XLH/XLS SERVICE INFORMATION

Transmission Vent Hose Routing — 1981 Models

Figure 1. Routing Transmission Vent Hose

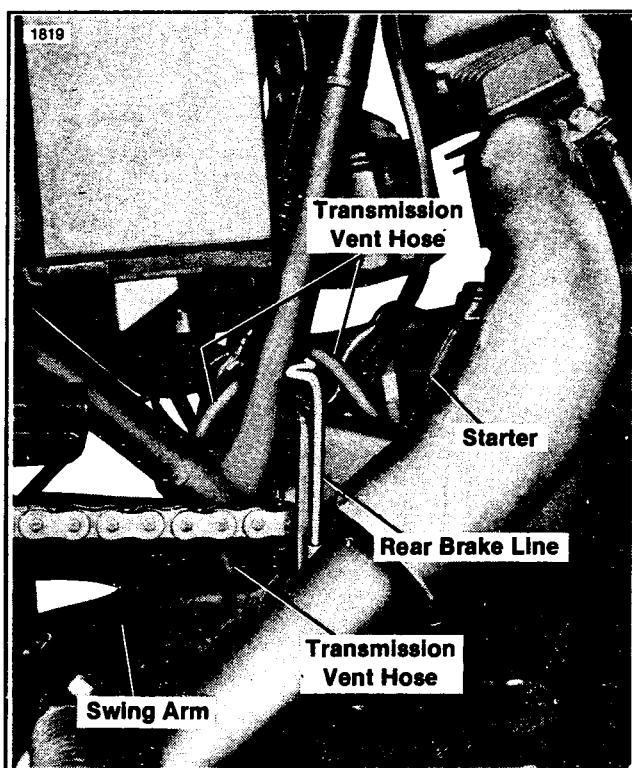
The transmission vent hose routing on the 1981 XLH/XLS models was recently changed to reduce excessive oil leakage from the transmission. Early 1981 models can be changed to the new routing.

See Figure 1. The transmission vent hose should be routed under the starter, over all the oil lines and the rear brake line, then down between the pivot bolt and swing arm.
